Product: Pegasus S2/S3

Title: LED Light Fitment

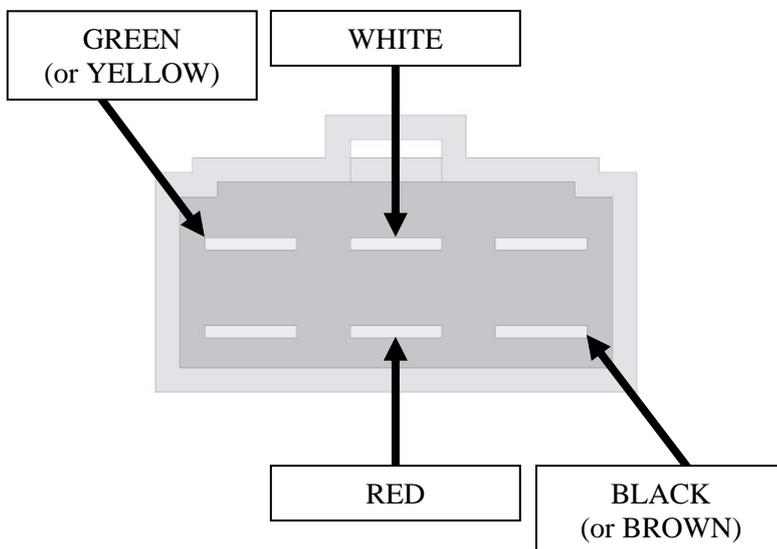
On the Pegasus Series 3, the brake and indicator lights on the mudguard have been superseded by LED unit.

For spare parts purposes, the new LED can be retro-fitted to either mudguard on a Pegasus Series 2 by using the diagrams on page 1 and 2, there are two types of Mudguard used on series 2, one has a Stainless Steel Mount for the Lights and the other has a moulded mount for the Lights. Both types are detailed below.

Shown opposite is the terminal layout for fitting the plastic plug to the Tail Light terminals.

The image opposite is from the **REAR** of the Plug! This is the side that the terminals are fitted into!

This wiring layout suits left **AND** right hand Tail Lights.

Ensure that the terminals are fitted as shown opposite or the Lights will not function correctly!
